Falcon Storage Expansion Transportation Memorandum

AUGUST 12, 2021

LSC #S214430

LSC Responses to Falcon RV Storage -- EPC Redline Comments

Figure 2
Site Plan

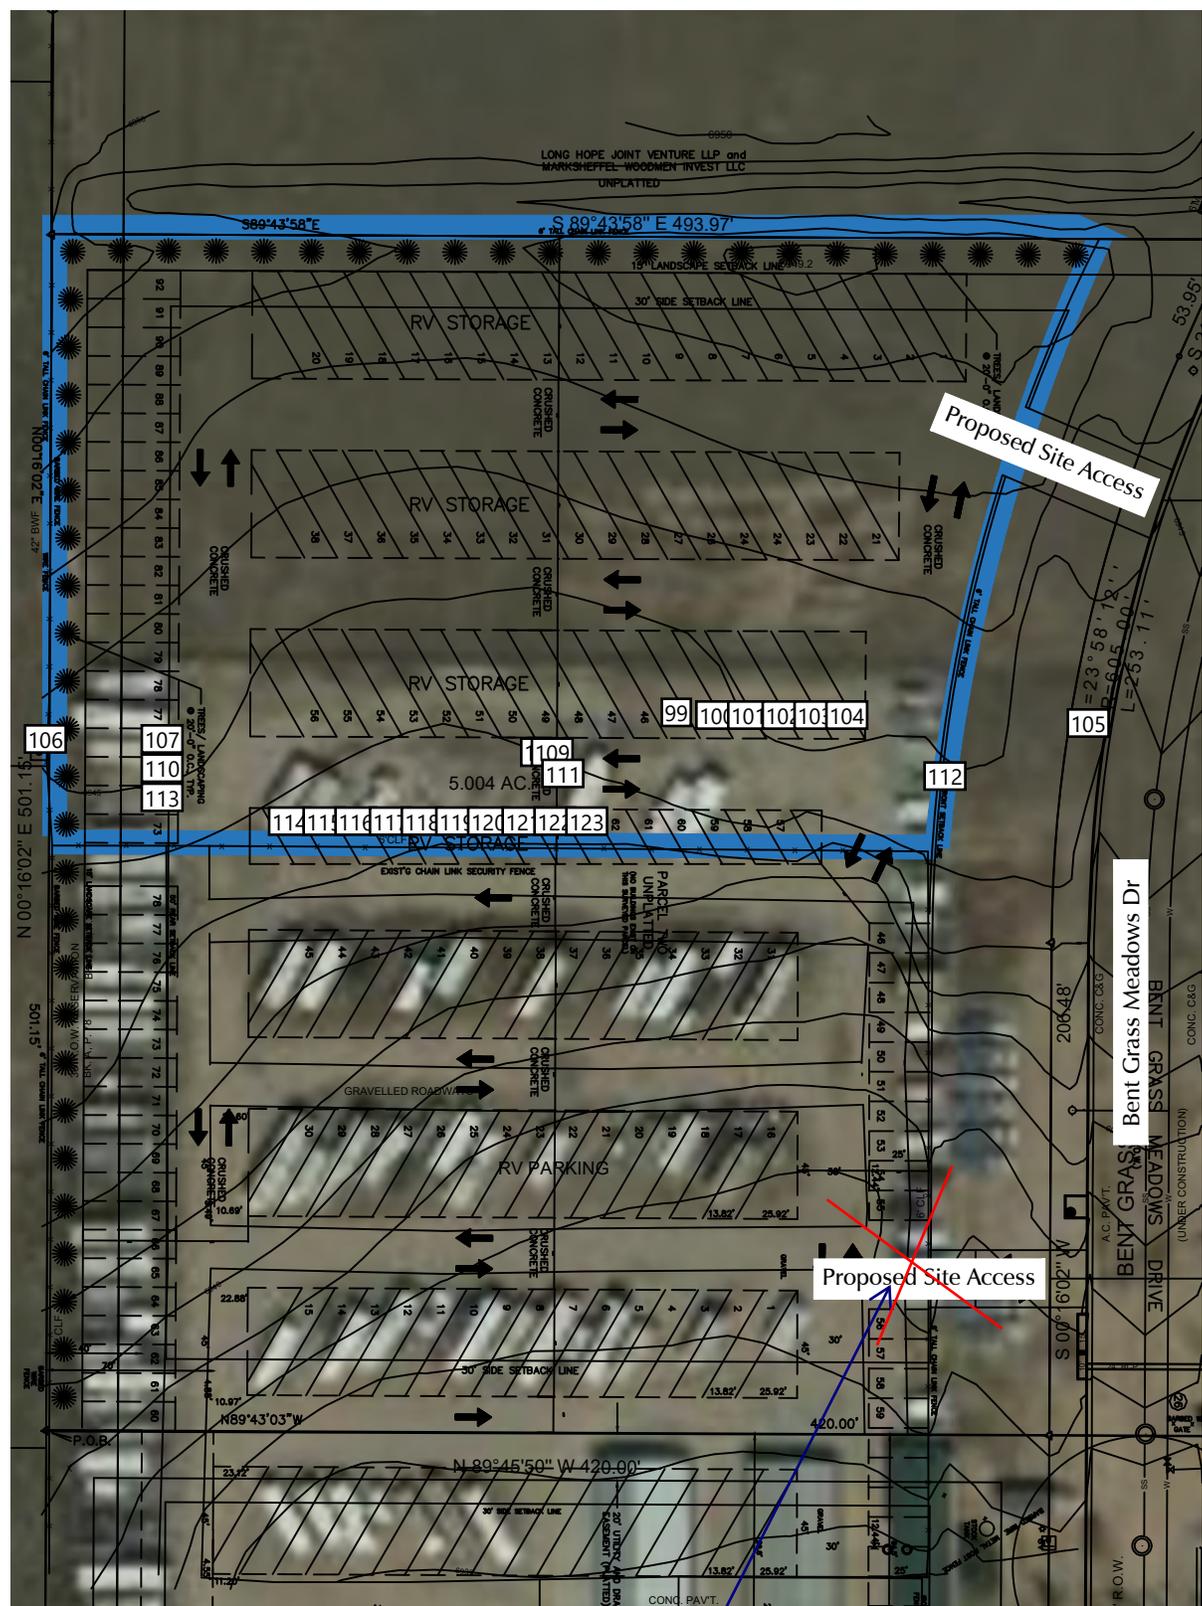
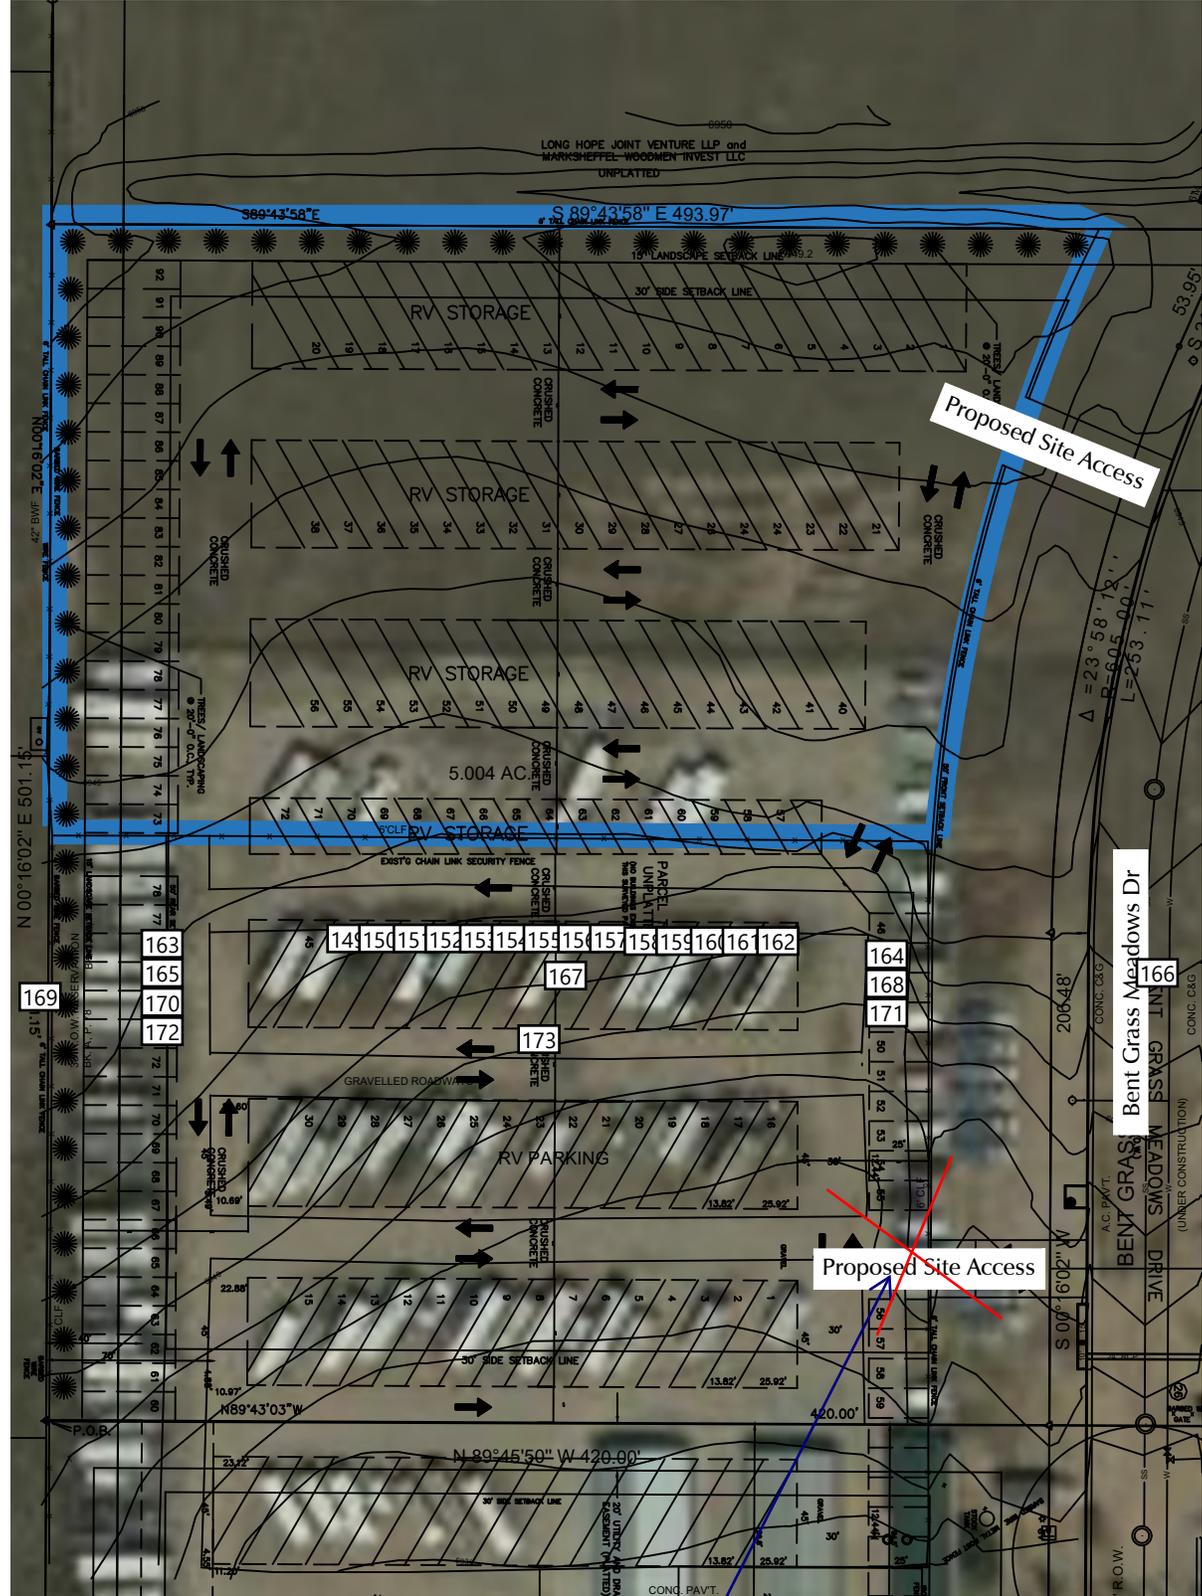
Please update the site plan to match the current proposed plan showing a single new access point

Author: jchodsdon Subject: Sticky Note Date: 7/17/2023 9:18:23 AM
LSC Response: The TIS has been updated accordingly.

Figure 3
Existing Traffic, Lane Geometry, Traffic Control, and LOS

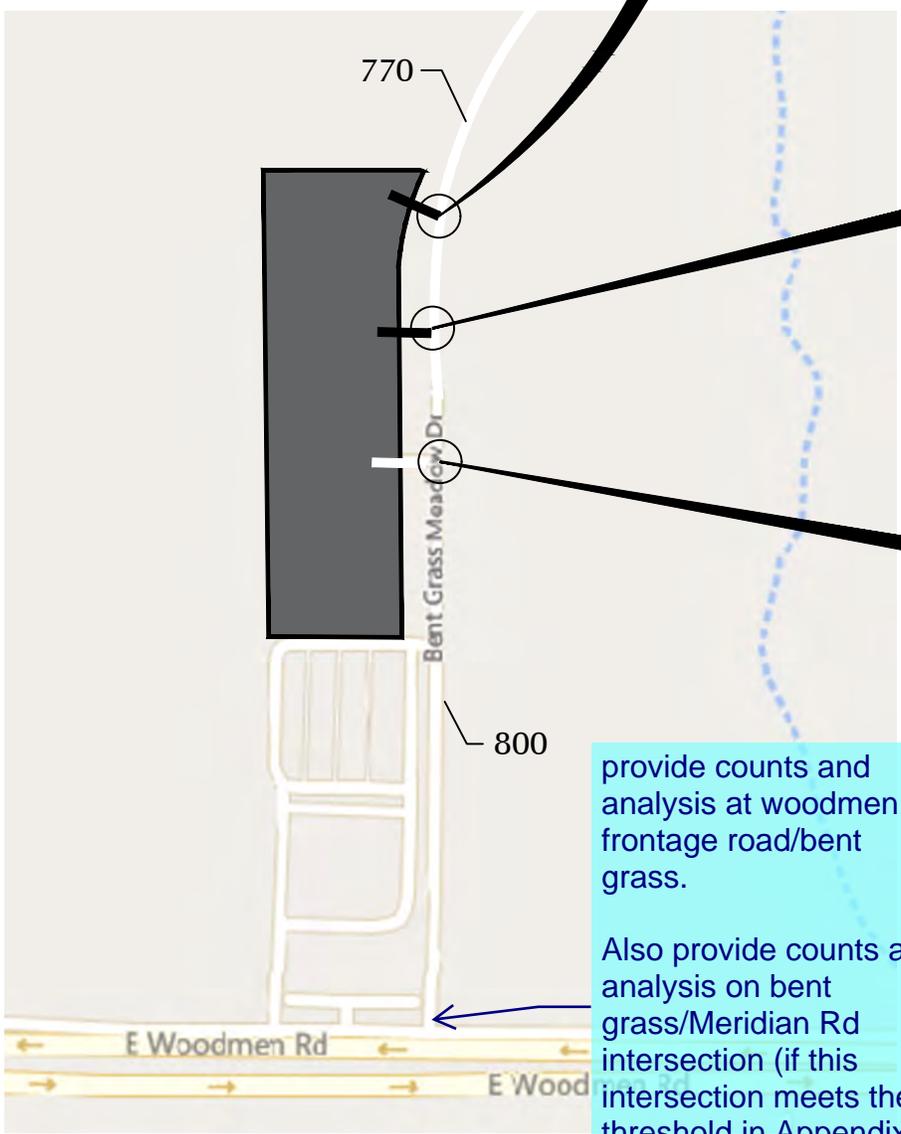
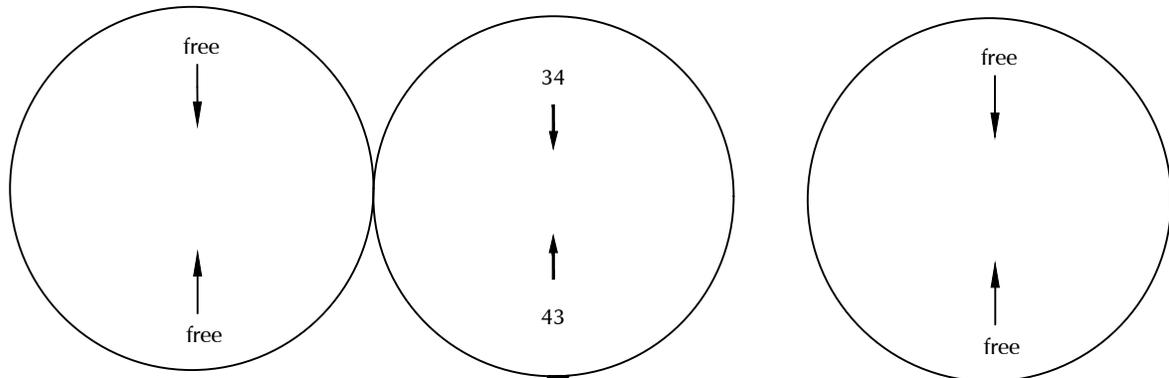
provide counts and analysis at woodmen frontage road/bent grass. Also provide counts and analysis on bent grass/ Meridian Rd intersection (if this intersection meets the threshold in Appendix B). If it doesnt then please state that in the narrative.

LSC Response: The TIS has been updated to include the intersection of Bent Grass Meadows Drive/Woodmen North Frontage Road. Regarding Bent Grass Meadows Drive/ Meridian, this intersection has not been included per the evaluation in the section of the report entitled "Percent Impact Calculations - Verification of the Study Area."
